SAWTOOTH SERENADE

Project: **SAWTOOTH SERENADE**
260 N 1ST AVE
KETCHUM, ID

COMMENT RESPONSE A

COMMENT RESPONSE - PLANS

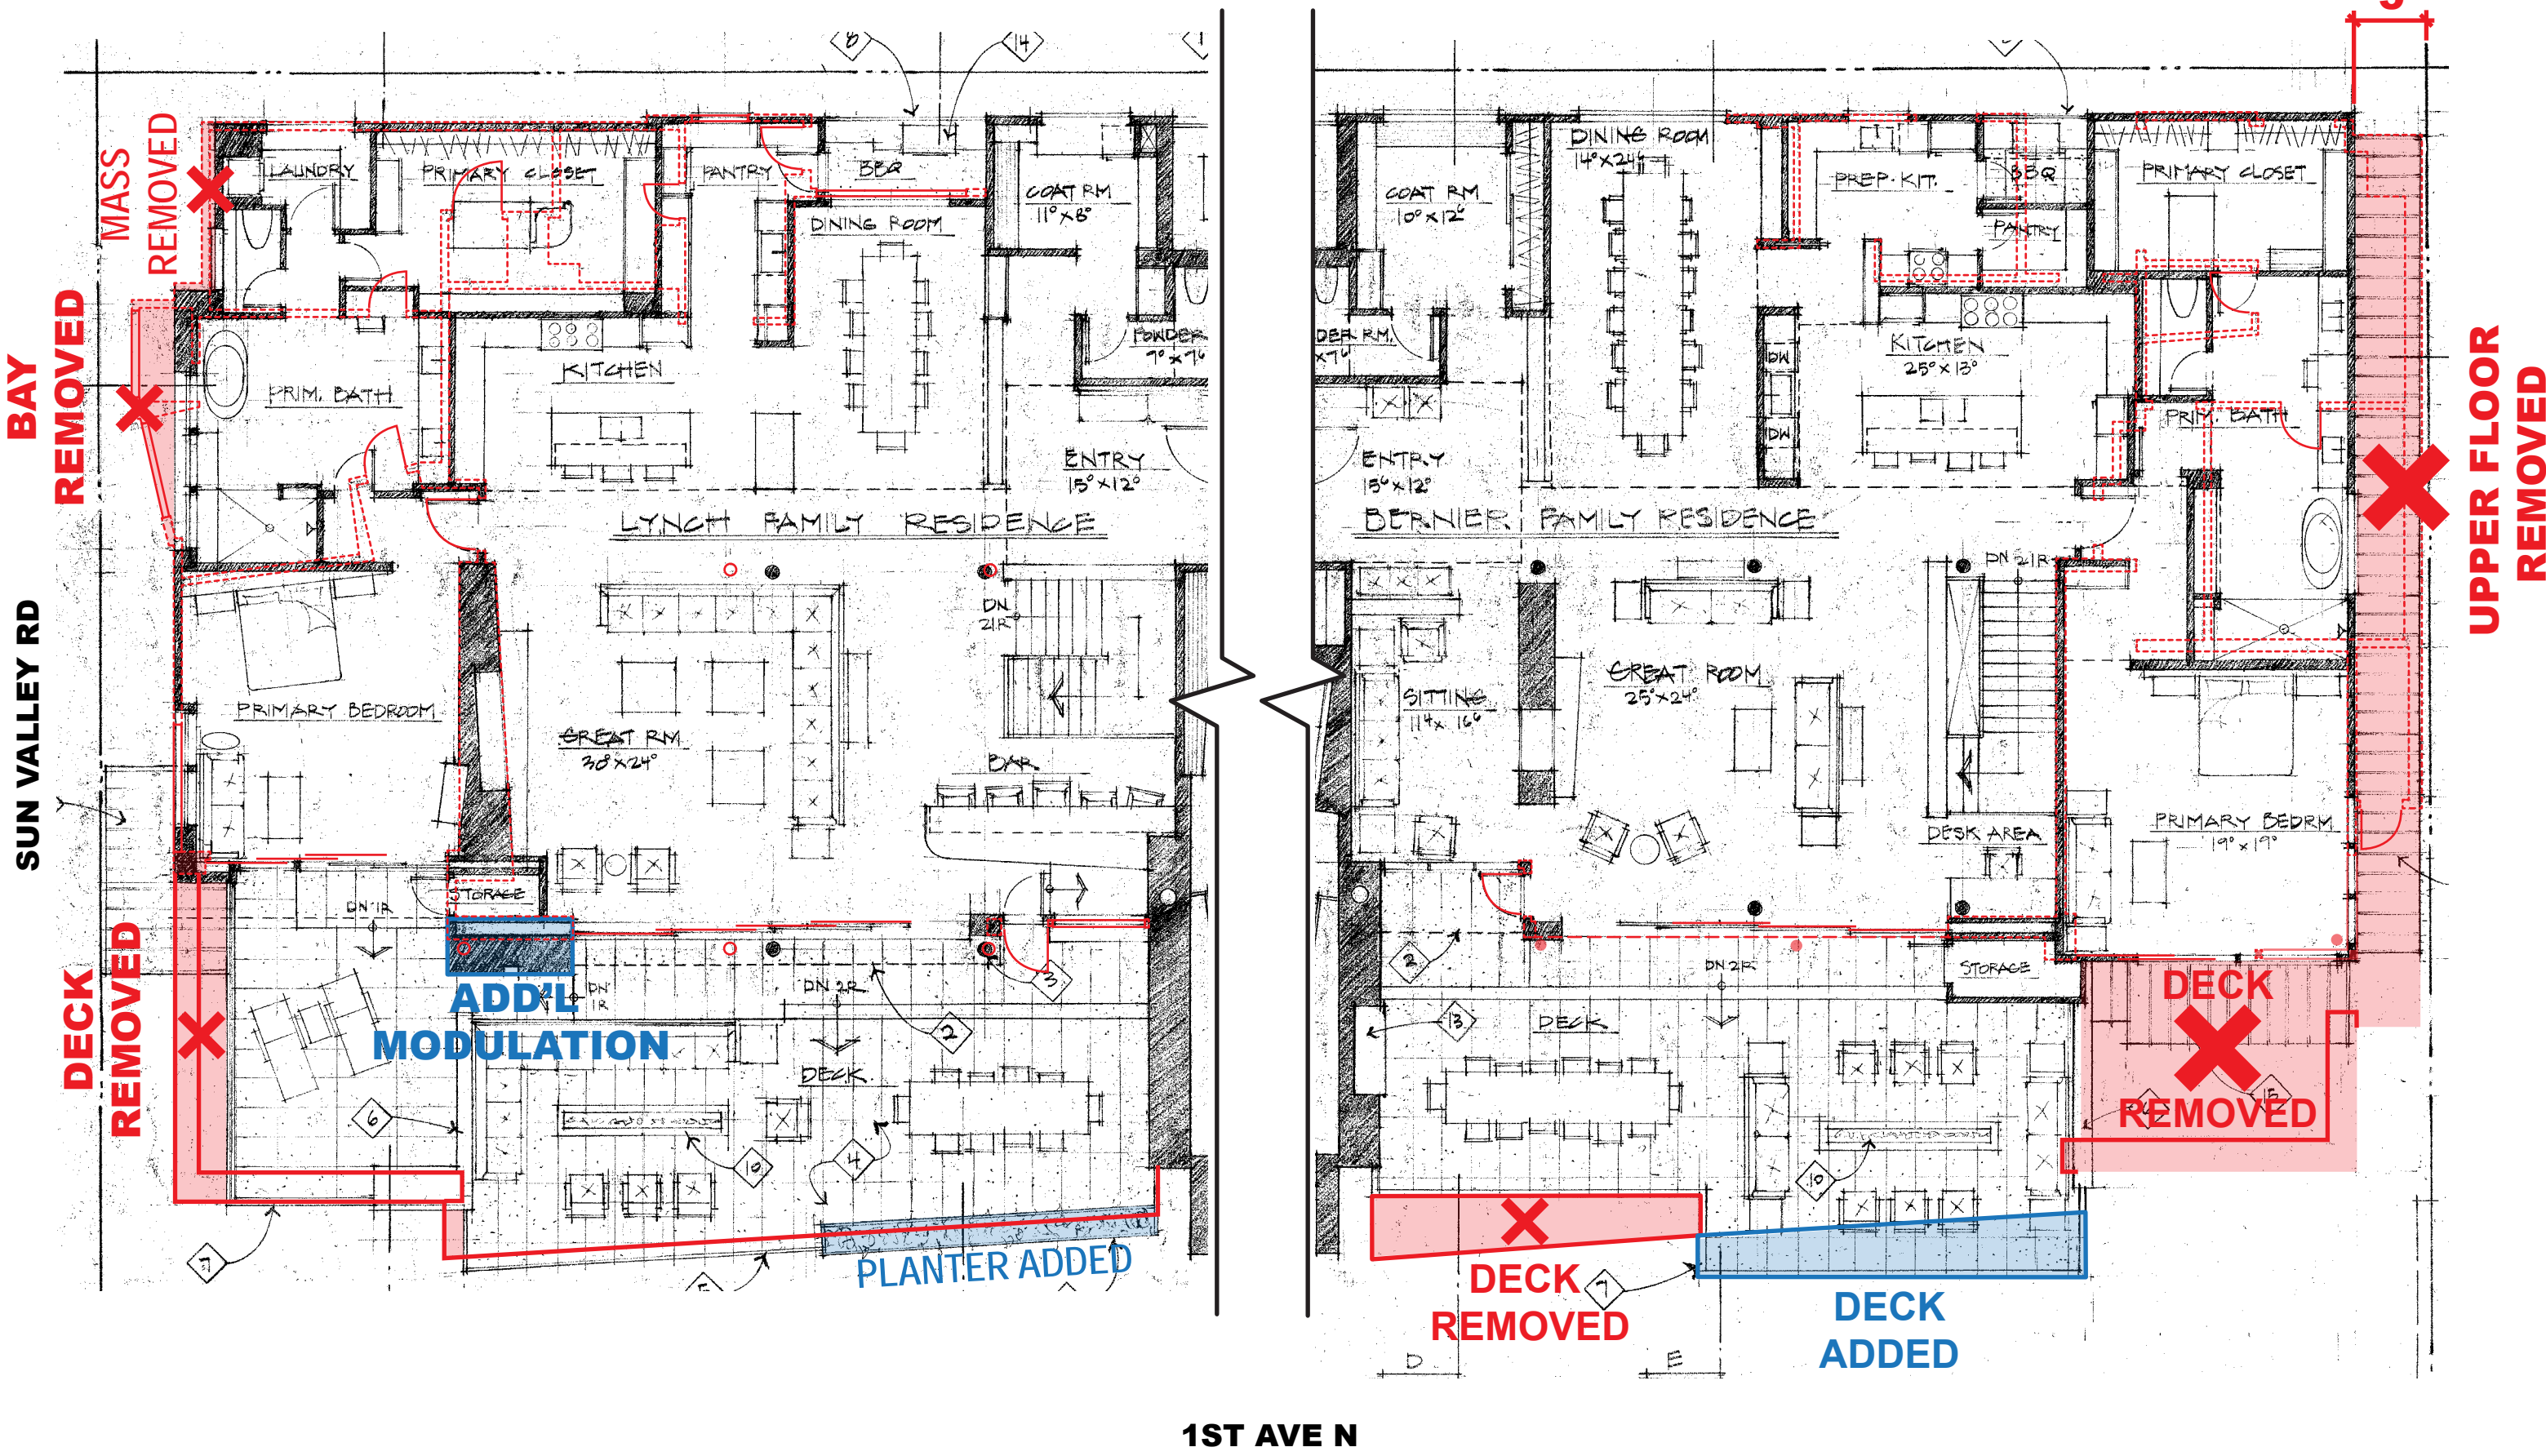
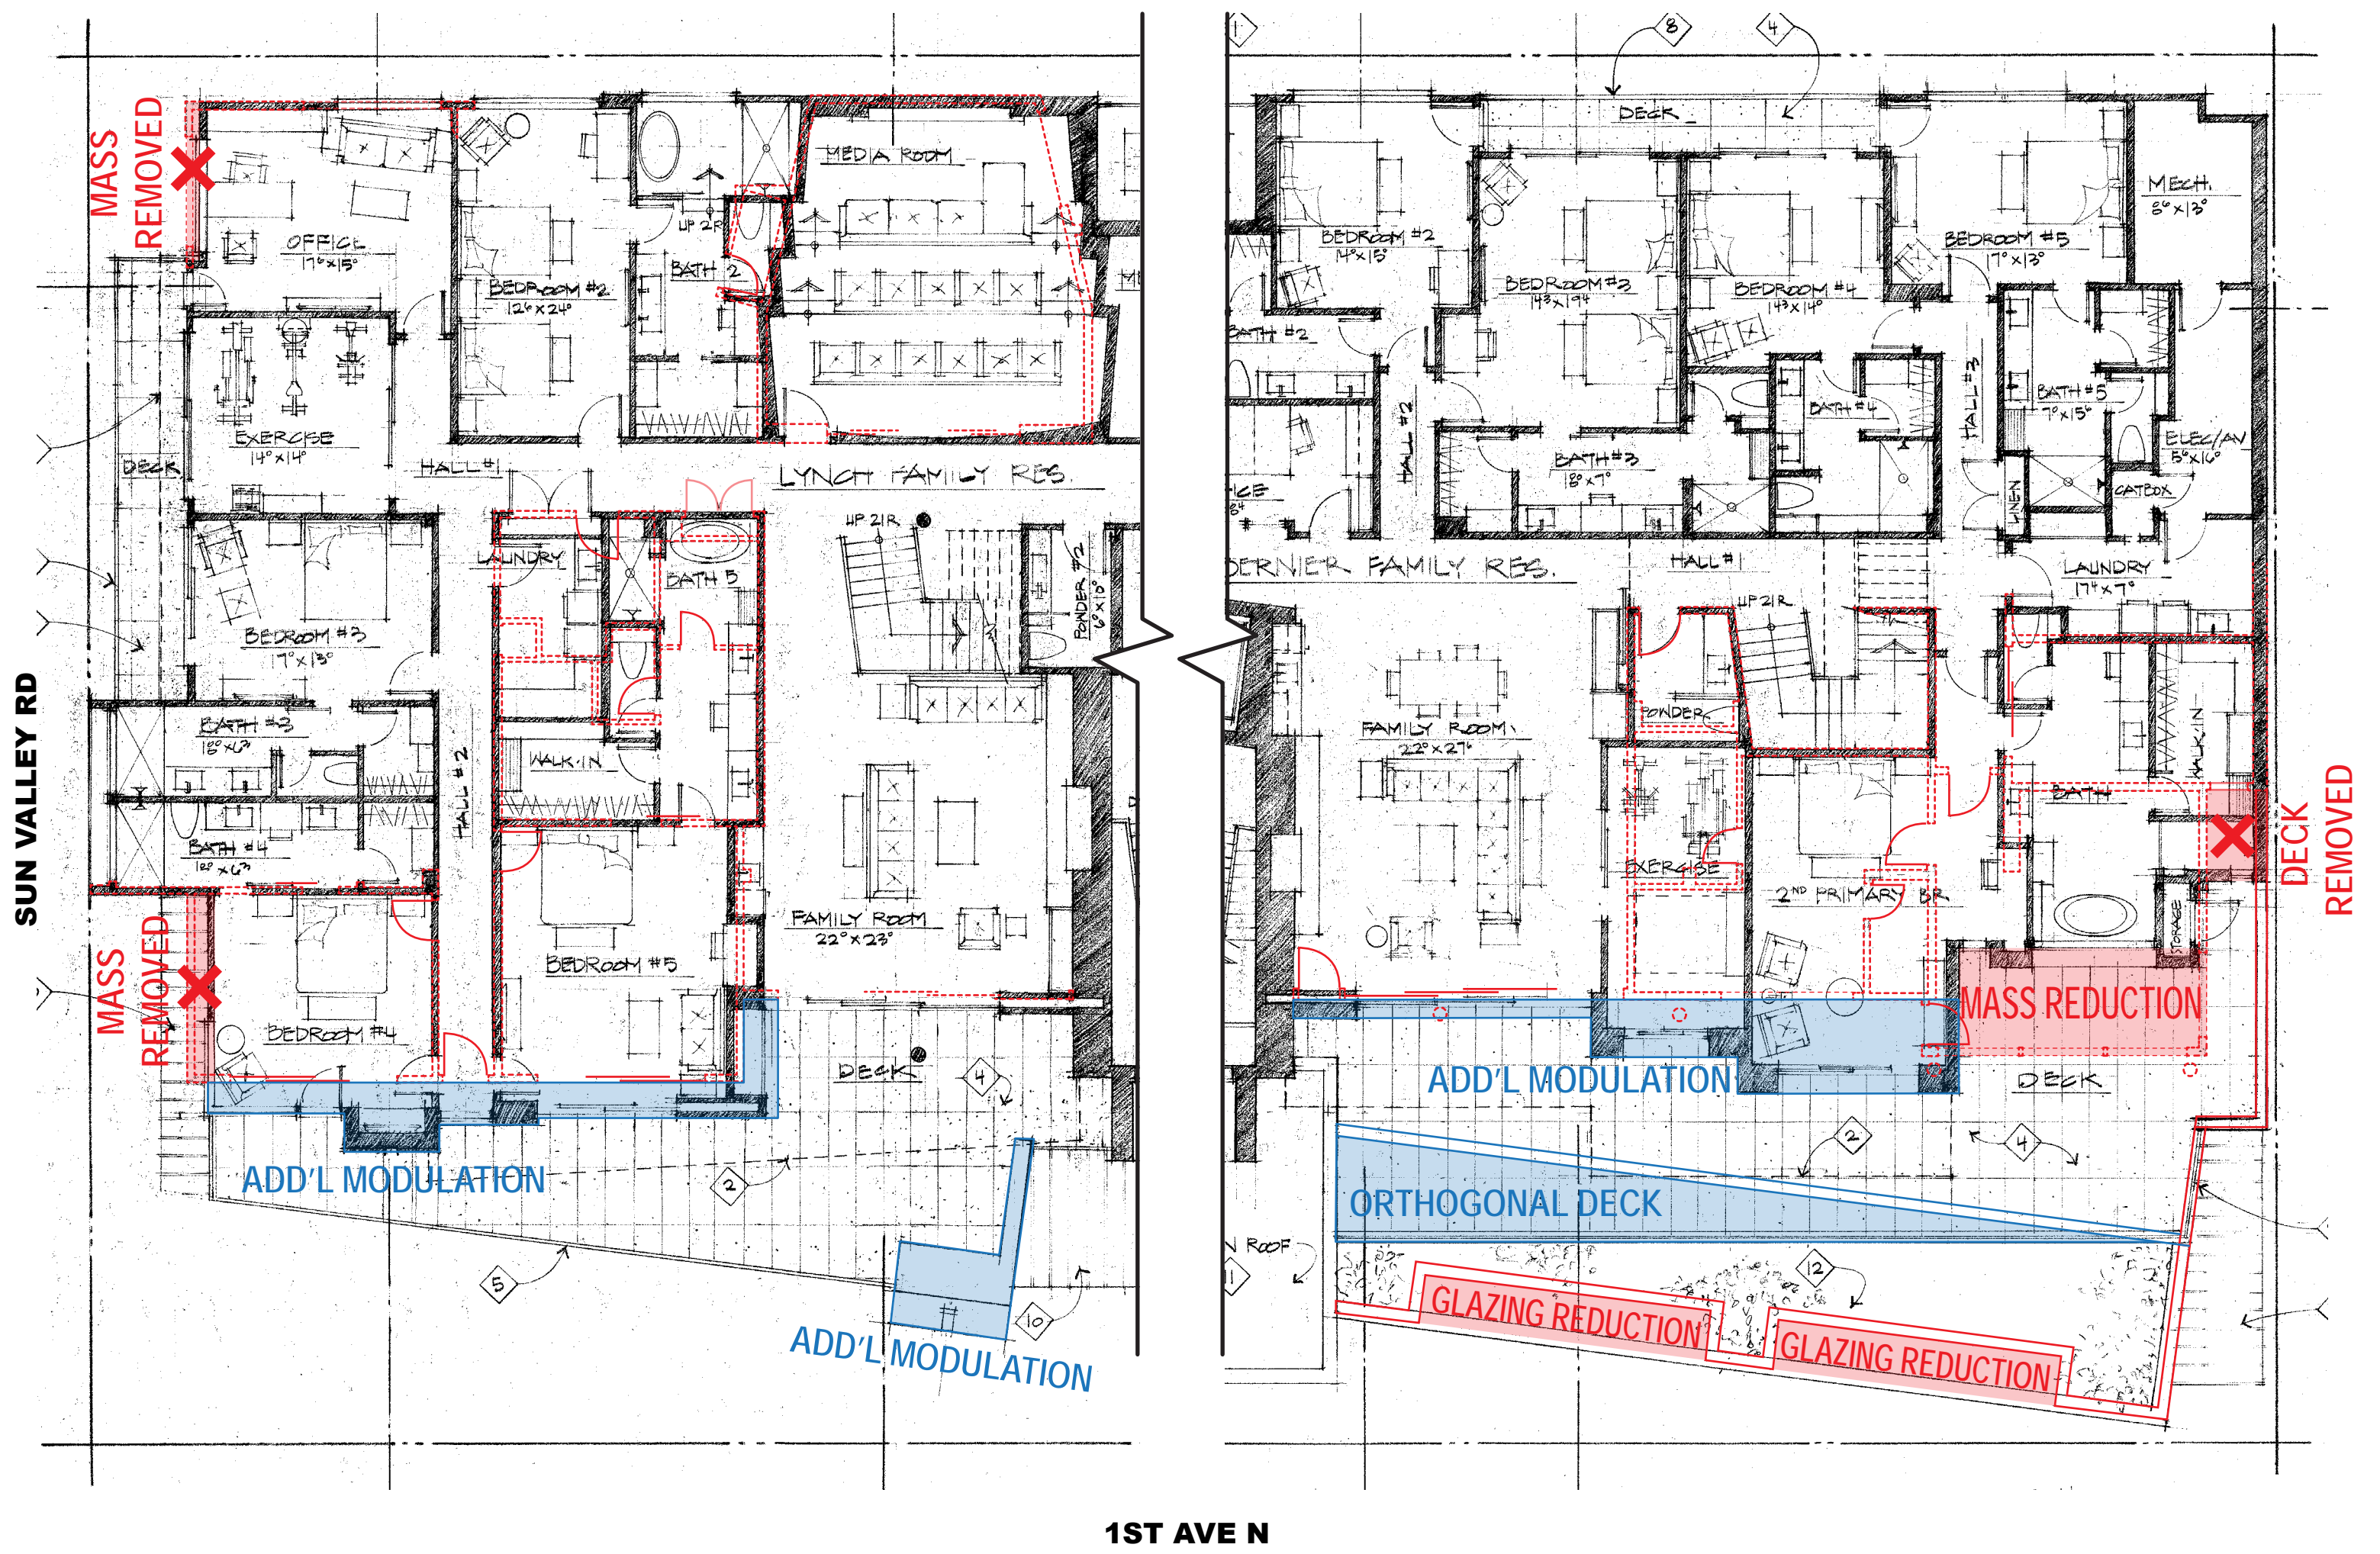
Below are plans documenting the itemized changes that have occurred between cycle 1 and the current design. Sections highlighted in **RED** have been removed. Sections highlighted in **BLUE** have been added. Dashed red lines represent interior changes.
